TRENCH TO SECONDARY PEDESTAL

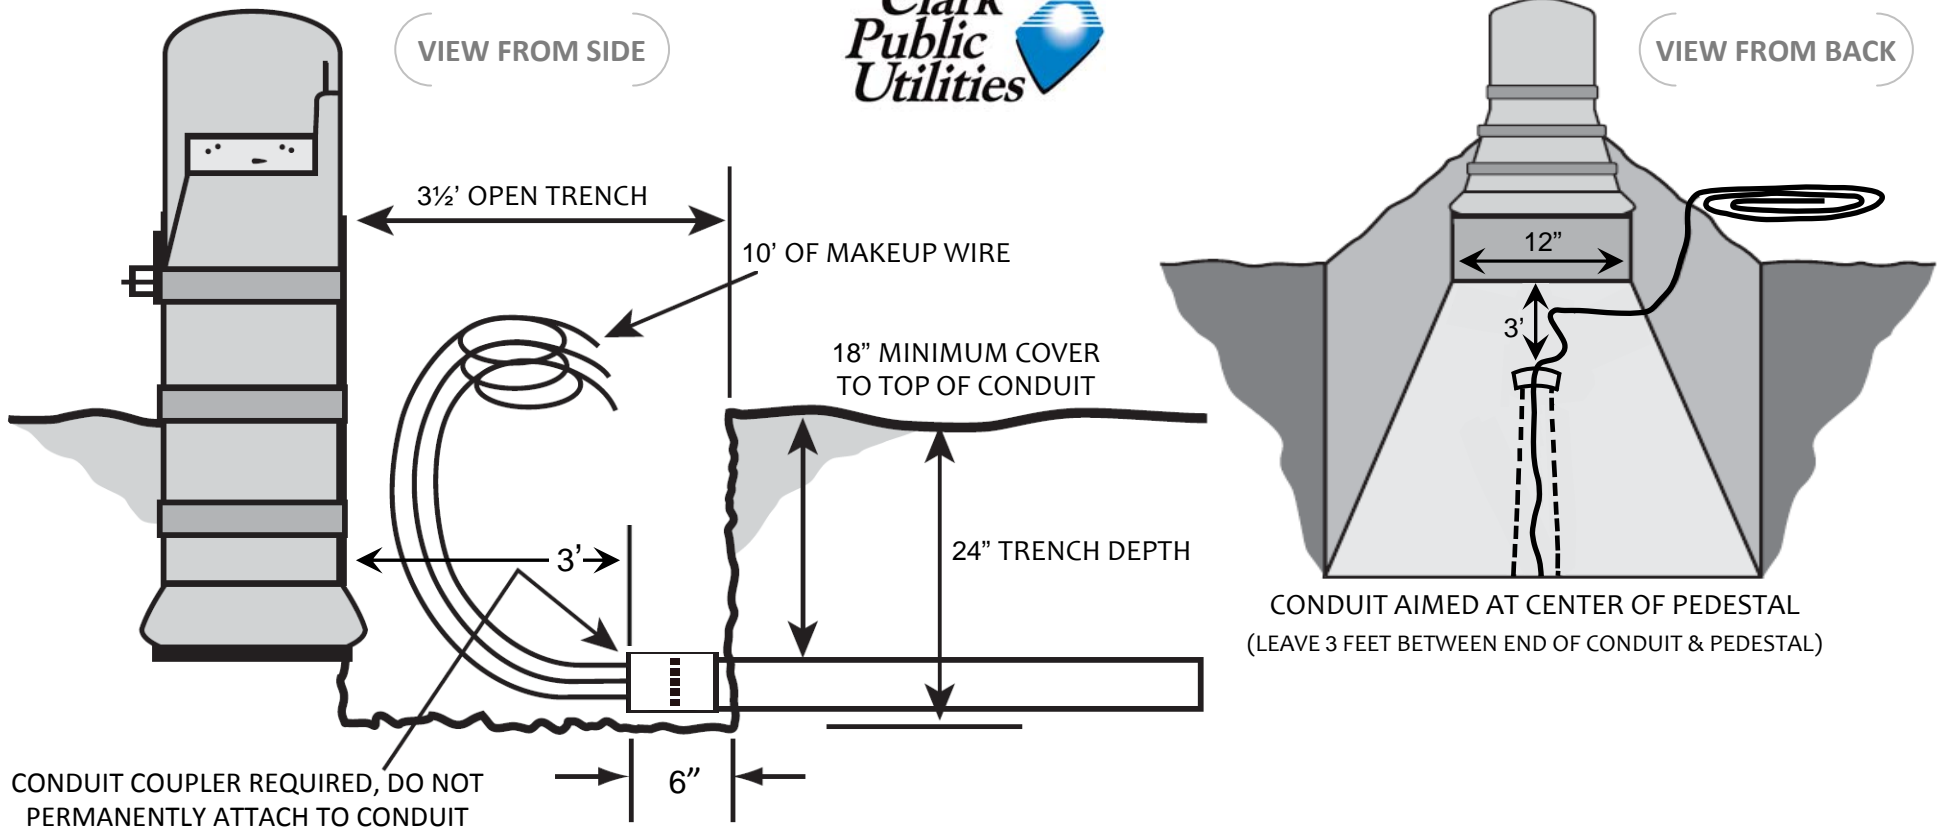
- DIG OUT TRENCH AS SHOWN IN DIAGRAM
- REQUIRED TRENCH DEPTH IS 24" (THIS INCLUDES THE PORTION LEFT OPEN FROM THE END OF THE CONDUIT TO THE BASE OF THE PEDESTAL)
- ELECTRIC SERVICE BLOCKED BY ANOTHER UTILITY
- STOP CONDUIT 3 FEET BACK FROM BASE OF PEDESTAL
- CONSTRUCTION DEBRIS IN TRENCH
- MINIMUM TRENCH WIDTH IS 12"
- NO ACCESS TO PANEL
- PANEL COVER MISSING
- LEAVE 6" OF CONDUIT EXPOSED (REMOVE ALL DIRT FROM TOP AND SIDES)
- CONDUIT NOT AIMED AT CENTER OF ELECTRICAL PEDESTAL
- OTHER: _____
